(12) **INTER PARTES REEXAMINATION CERTIFICATE** (1409th)

(10) **Number: US 8,245,764 C1**
(45) **Certificate Issued: Apr. 17, 2017**

(54) **COOLING SYSTEM FOR A COMPUTER SYSTEM**

Reexamination Request:
No. 95/002,386, Sep. 15, 2012

Figure 7 of Koga

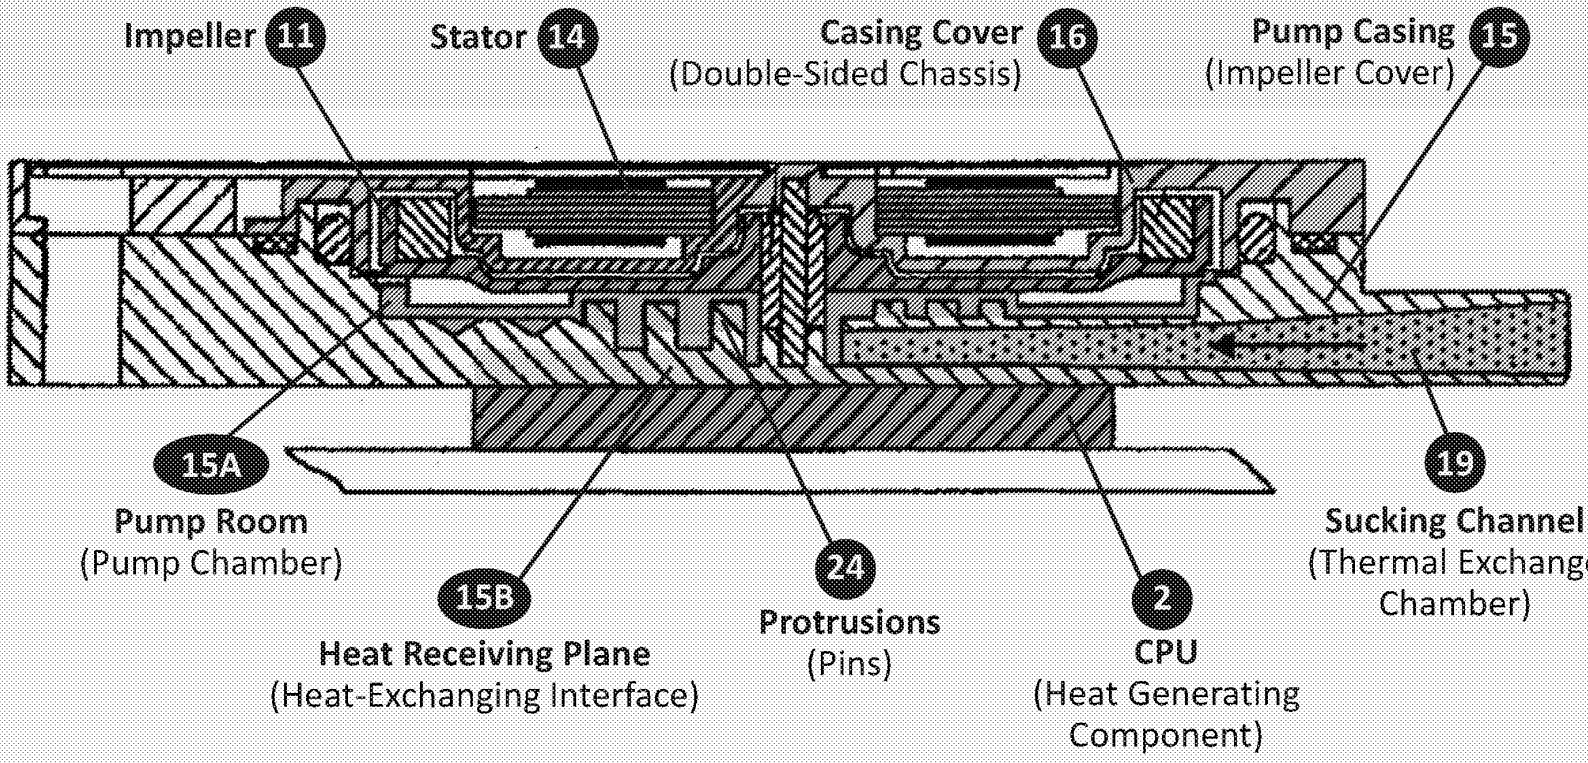
On December 3, 2014, Asetek orally moved, pursuant to Rule Fed. R. Civ. P 26(a)(2) and 37(c)(1), to exclude CMI USA's slide reproducing Figure 7 of U.S. Patent No. 7,544,049 to Koga et al. ("Koga") colored to illustrate where certain claim elements are disclosed[1], and to exclude testimony by CMI's expert, Dr. Gregory Carman, that the recesses shown on the left side of Figure 7 are part of the "thermal exchange chamber" disclosed by Koga. The motion should be denied. First, Dr. Carman's July 3, 2014 expert report sufficiently disclosed his opinions regarding where Koga discloses the required thermal exchange chamber. Second, to the extent that the opening expert report failed to disclose every part of Koga's Figure 7 that Dr. Carman opines is part of its thermal exchange chamber, Asetek has suffered no prejudice. Dr. Carman's report disclosed the proposed testimony with sufficient specificity for Dr. Donald Tilton, Asetek's expert to prepare his rebuttal to it. Third, Asetek chose to explore Dr. Carman's opinions in response to Dr. Tilton's opinions in Dr. Carman's deposition. In that way, Asetek was able to explore Dr. Carman's opinions over three months before the beginning of trial. Under these circumstances, to grant Asetek's motion would result in fundamental unfairness in the trial.

Asetek's counsel repeatedly questioned Dr. Carman about whether recess 15 F in Figure 7 is part of the pump room. *Id.* at 216-219. Dr. Carman repeatedly offered the opinion that the region labelled 15 F is part of the thermal exchange chamber he believes Koga discloses.

And you can see that also in Figure 7, where, if you look at where you're pointing to (15A), that bottom wall is elevated than if you go over to where (15F) is.

And, once again, you can see that in Figure 7. And there, you need to look at where the bottom boundary of -- let's say where (15F) is pointing to and where (15A) is pointing to. There are two heights there. One is above the other.

FIG. 20

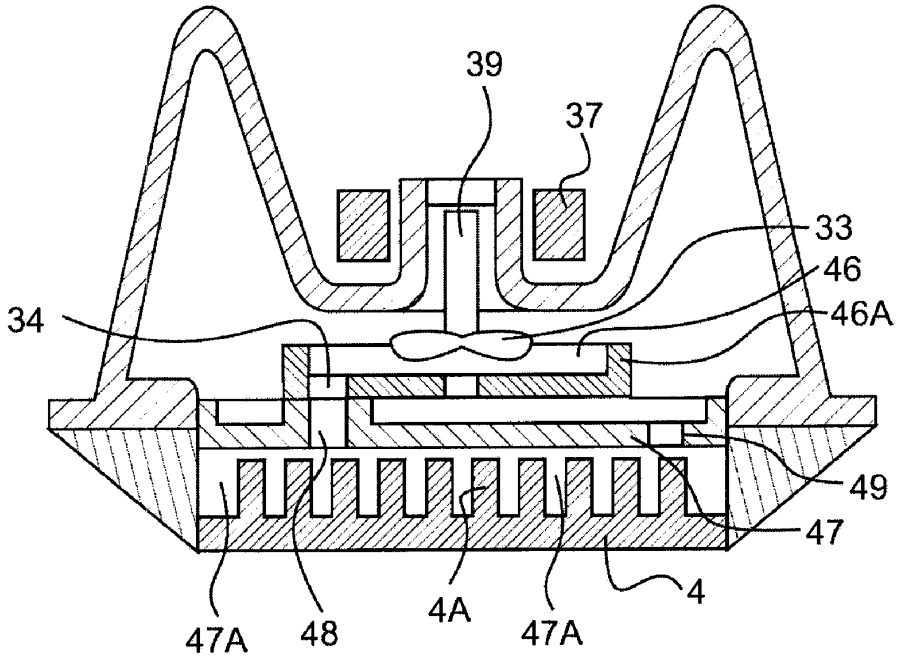
As explained more fully in the Request, Patent Owner added FIG. 20 more than two years after the International Application published. Request, pp. 15-19. Substantial description of that drawing was added to the specification in a fourth preliminary amendment, almost five years after the International Application published, i.e., on July 14, 2011. Ex. 12, Preliminary Amendment of July 14, 2011, p. 8.

The entire written description inquiry revolves around whether subject matter is clearly identified. By the Appellant's own admission, the subject matter contained in FIG. 20 and the passages added to the specification were NOT clearly identified. App. Br. 29:22-23. On that basis alone, priority to earlier than July 14, 2011, should remain denied.

Moreover, by adding FIG. 20 and the corresponding written description of that drawing to the specification years after the International Application was filed, Appellant clearly believed there was a deficiency in the earlier application's disclosure. However, mere inference is not required – Appellant admitted during prosecution of the Parent Application, and since has reiterated in this appeal, that the amendments were made "to help clearly identify" subject matter that was not clearly presented earlier. App. Br. 29:22-23.

Requester has stated that Patent Owner is only eligible for the effective filing date of 7 October 2011 as the original application did not have Figure 20 or the

Requester has stated that Patent Owner is only eligible for the effective filing date of 7 October 2011 as the original application did not have Figure 20 or the passages in the specification to support the claimed subject matter. This material was added on 9 January 2009 and 14 July 2011. Therefore, the Examiner will use the effective filing date of 14 July 2011.

FIG.7

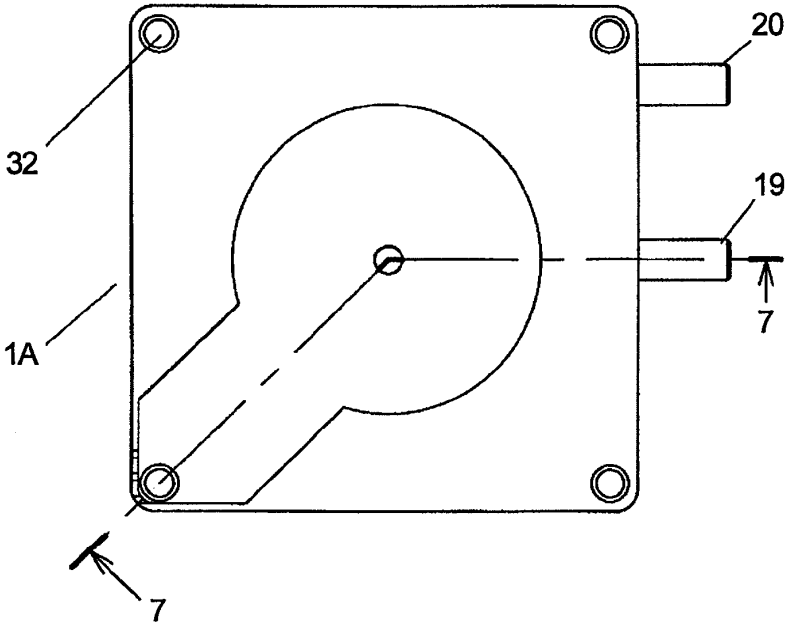
In addition, *Koga* teaches that the "backside of heat receiving plane 15B" can be dimpled or have fins (e.g., protrusions). *Koga*, 6:52-53, FIG. 7. Such fins are shown in FIG. 7 (reproduced above in Section I). *Koga* explains further that such features on the "backside" facilitate heat transfer from the casing wall 15 to the coolant 41 by disrupting a boundary layer. Koga, col. 6:56-62. Still further, *Koga* explains that the casing 15 and thus the protrusions are made of "highly conductive material," which further increases heat transfer to the cooling liquid in the thermal exchange chamber 19. *See, e.g.*, Koga, col. 10:22-23. Therefore, *Koga*'s fins constitute "features that are adapted to increase heat transfer from the heat exchanging interface to the cooling liquid in the thermal exchange chamber," as claimed in claim 4.

merely requires that a side of the heat exchanging interface include pins or fins. As the Examiner correctly notes, *Koga*, discloses that a side of the casing 15 positioned opposite the heat receiving plane 15B defines fins. *Koga*, 3:25-27, FIG. 7.

Koga et al. has been discussed in detail as noted in the above rejection. In addition, as seen in Figure 7, a passage directs cooling liquid from the pump chamber 15 directly to the thermal exchange chamber; an entire surface of the heat exchange interface that contacts the cooling liquid forms a boundary wall of the thermal exchange chamber as seen with either surface of 19 in Figure 7; and the pump and thermal exchange chambers are connected together by one of more passages as noted above and in Figure 7, and the reservoir has and inlet and outlet at 19 and 20 as seen in Figure 8.

Regarding claim 4 and by extension 5, looking at Figure 7 of Koga et al., pins 24 and 24A increase the surface area of the heat exchange unit 15B. 15B is the wall of the thermal exchange chamber. Therefore, the pins are the features that "are adapted to increase heat transfer from the heat-exchanging interface to the cooling liquid in the thermal exchange chamber".

Examiner: As seen in Koga et al., Figure 7, the chambers are vertically spaced apart. There is no basis for Patent Owner's contention that they are not. Chamber 19 lies below 15A.

FIG.7

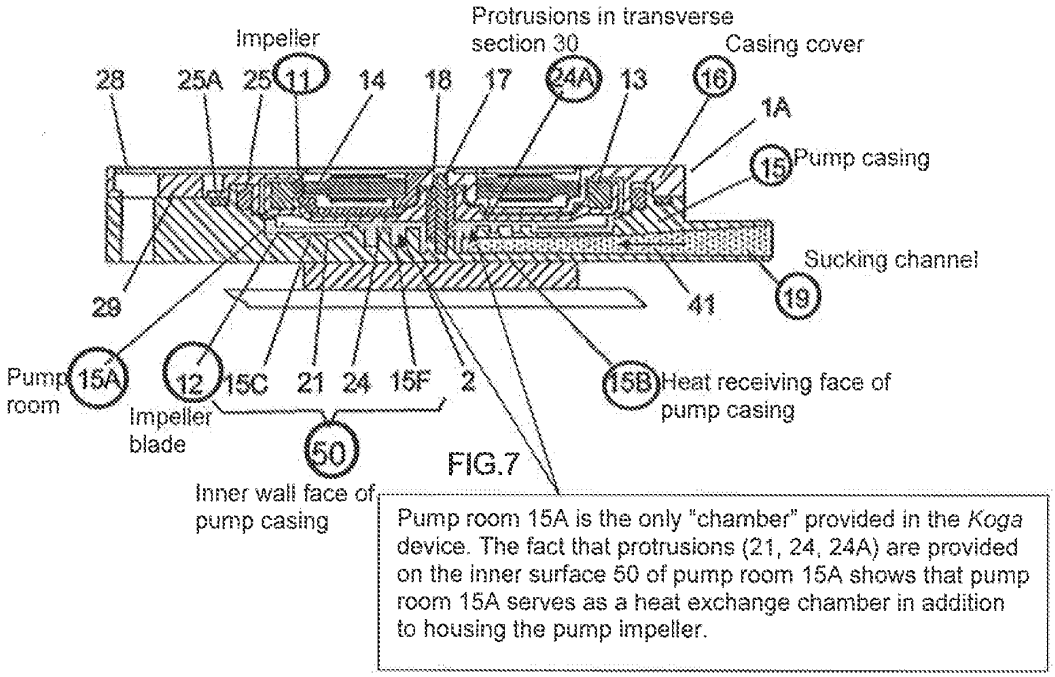
Koga represents sucking channel 19 as simply a conduit to deliver coolant to the rotational center of the impeller. *See* Ex. 2 [Koga], 4:57-67; *see also* Ex. 6 [Tilton Decl.] ¶¶9-11. Indeed, nowhere does *Koga* disclose a "thermal exchange chamber" *separate* and distinct from the "pump chamber." The purpose of *Koga*'s invention is to downsize and slim-down the cooling device so that it can be mounted in a compact portable electronic apparatus, such as notebook-size computer. Ex. 2 [Koga], 3:28-30; 4:3-9. To this end, *Koga* teaches combining the pumping and the heat exchange functionalities of the cooling device into a *single* chamber (i.e., pump room 15A). *Id.* at 6:26-33, 6:50-62, 8:11-39, 9:52-10:21; Ex. 6 [Tilton Decl.], ¶11. FIG. 7 of *Koga*, annotated below, illustrates that pump room 15A (shown in yellow) is the *only* chamber provided in the cooling device of *Koga*, and it performs the dual function of collecting and absorbing thermal energy dissipated from heat-generating component 2 (and thus act as a thermal exchange chamber of sorts), as well as housing impeller 11 (and thus acts as a pump chamber of sorts).

In fact, *Koga* teaches that the cooling device be designed in such a way that sucking channel 19 does not extend over heat-generating component 2, in order to allow heat-receiving face 15B of the base wall of the *Koga* device and the upper surface of heat-generating component 2 to be in better contact with each other to allow efficient transfer of heat into pump room 15A through the base wall. Specifically, *Koga* teaches that:

FIG.8

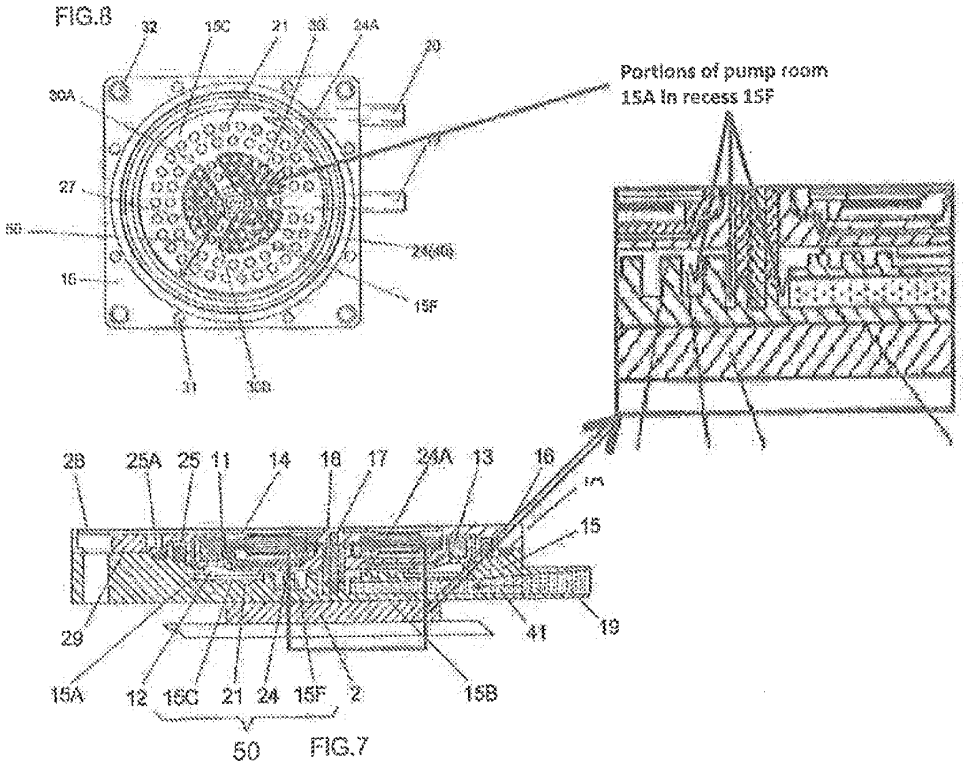
In the Office Action, pump room 15A of *Koga* is interpreted as the recited "pump chamber" of independent claims 1, 10, and 15. Request, pp. 151, 157, 160. And, sucking channel 19, that supplies coolant 41 to the pump room 15A (the alleged "pump chamber"), is interpreted as the recited vertically spaced apart "thermal exchange chamber" of independent claims 1, 10, and 15. See, Request, pp. 152, 157, 161. However, sucking channel 19 is not a "chamber" of *Koga*'s pump room 15A. As can be seen in FIG. 8 reproduced above, it is only a conduit that supplies coolant to the pump room 15A. As the Examiner correctly pointed out "[t]he definition of a chamber according to *Webster's New World Dictionary, Third Edition*, is 'any enclosed space; compartment…'." Order Granting/Denying Request for *Inter Partes* Reexamination, pp. 4, 7[5]. Sucking channel 19 is neither an "enclosed space" nor a "compartment" of pump room 15A. It is merely a tube that supplies coolant to the pump room 15A. Col. 8:65-67; *See* FIG. 8.

FIG.7

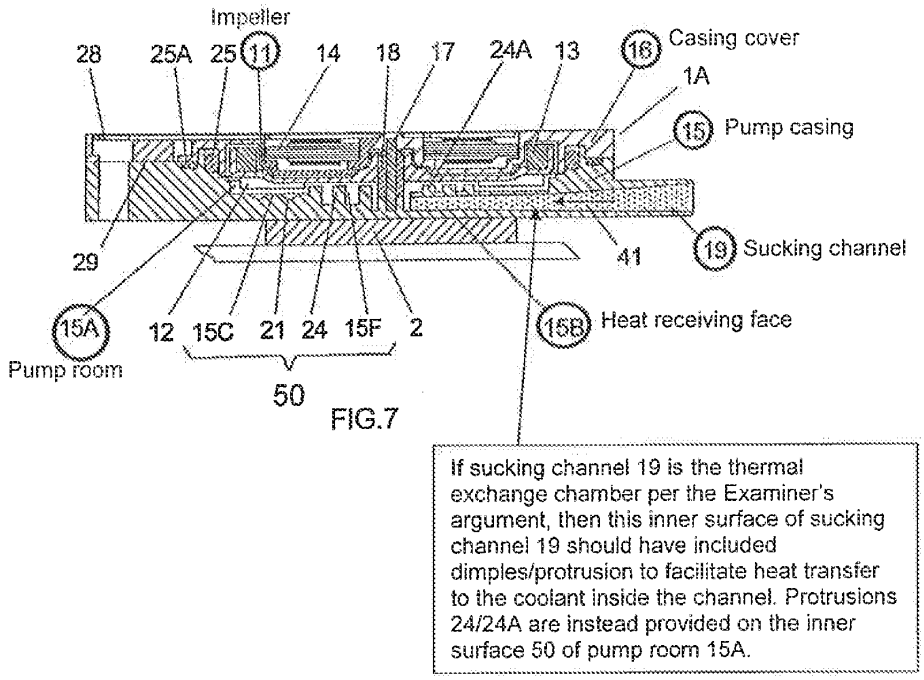
Koga teaches that dimples, or protrusions extending towards the impeller, may be provided to help in transfer of heat from the pump casing 15 to the coolant. *See Koga*, col. 8, ll. 11-22. However, the protrusions and/or dimples are provided on the inner surface of the pump room 15A, as shown in FIG. 3 (showing that protrusions 24 and dimples 40 are located on recessed area 15E of inner surface wall 50 of the pump room). *See also Koga*, col. 3, ll. 25-27 ("On the inner wall of the pump room, a recess is provided. In this recess, protrusions extending toward the impeller or dimples are provided.") Since sucking channel 19 is sandwiched between inner wall surface 50 and heat-receiving face 15B of the base wall, the sucking channel itself does not comprise any features to help in the transfer of heat. Thus the Examiner has improperly conflated the pump room 15A and the sucking channel 19. It is respectfully submitted that the
